MWI FIELD TRIP REPORT DURING INTIAL TESTING OF PUMPING EQUIPMENT DTD 24 APRIL 2006

MWI FIELD TRIP REPORT

Dennis Strecker

April 24, 2006

Figure 3

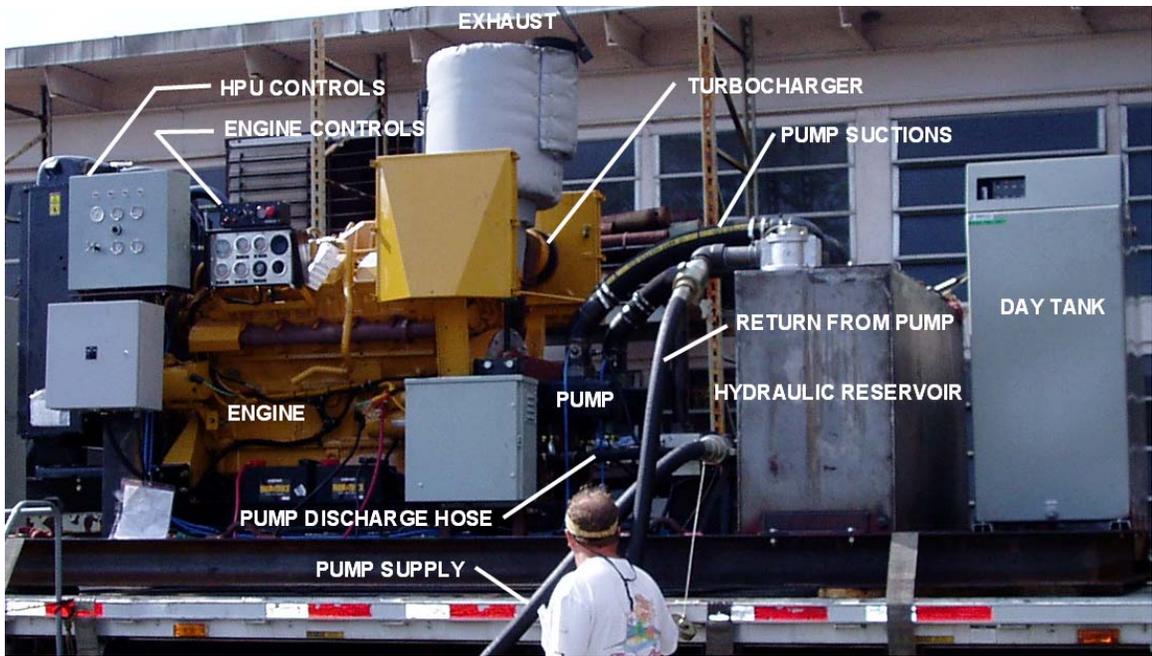
Other conditions which may have contributed to inaccurate test results were the test tank water, the unsteadiness of the water in the manometers, and use of a hand held tape measure for reading the manometer. The water in the test tank had debris from a recent fire and there was oil and froth in the water. See Figure 2. The water levels in the manometer moved around a lot making accurate reading and verification difficult. Two people were required to read the manometer; one would move the tape measure up and down trying to follow one leg of the manometer and the other would try to follow the moving water level in the opposite leg. The oil and debris in the tank may have affected the density and viscosity of the water and altered test results. After witnessing a test, I had a low confidence level in the accuracy of the tests.

Figure 4

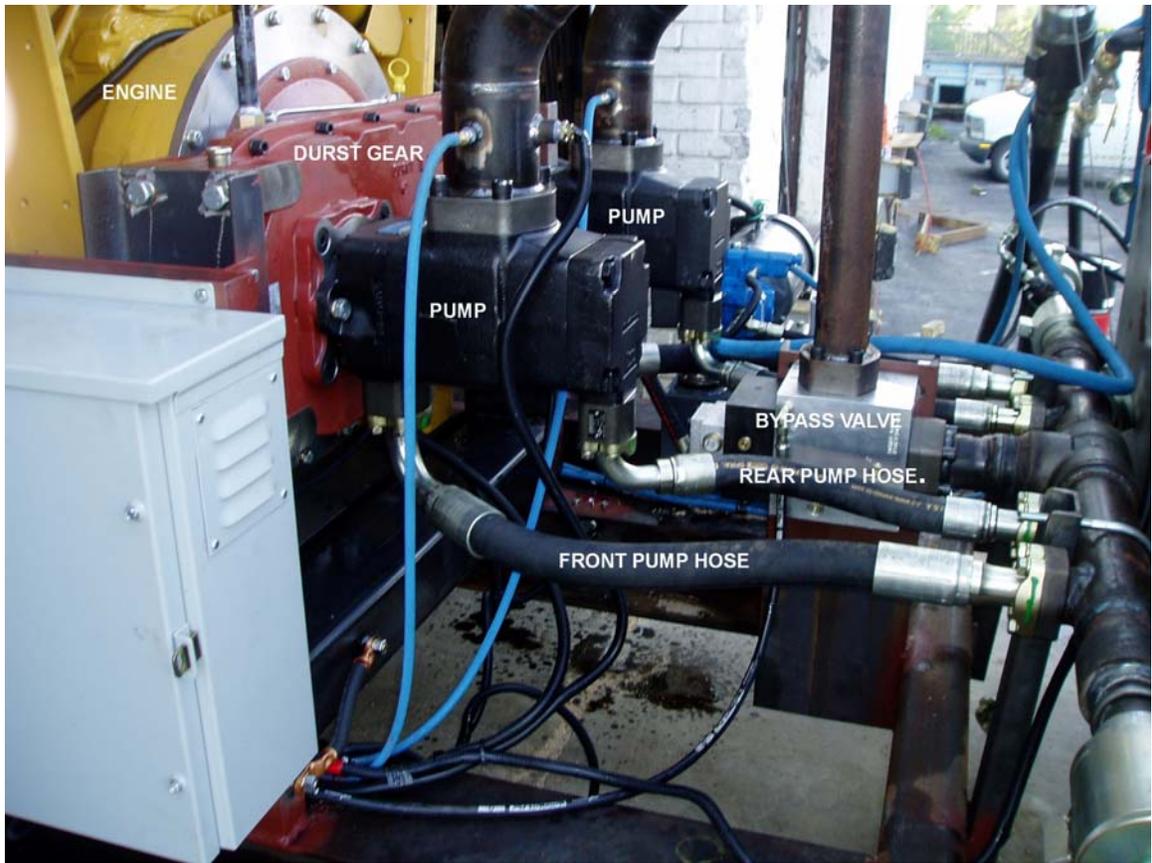
A potential fire hazard existed with the HPUs. On two occasions a hose on the rear pump of one of the double vane pump sprang a leak. The leak developed from blistering on the hose's jacket near the fittings, followed by a high pressure fine mist spray of hot oil. The pump was manually shutdown before the condition developed further. The hoses were located between the rear of the engine and the hydraulic reservoir and fuel tank. They were near the engine exhaust turbochargers. The rupture I observed occurred on the bottom side of the hose. There was a potential for a rupture which would spray oil on the engine exhaust or turbochargers. Operating pressures on the pump discharge hoses were 3000 psi.

1. The Corps should verify pump capacity with field testing. Because of the large clearance between impeller and impeller bowl of approximately $\frac{1}{4}$ " and less than ideal test conditions at the factory, a field test on one pump should be conducted. Typically, impeller to impeller bowl clearance is on the order of 0.060" for a 60" pump.
2. A spray shield between the hydraulic system hoses and engine exhaust should be installed. In the event of a ruptured hose, a spray shield would prevent hydraulic fluid from spraying on the engine's hot exhaust.
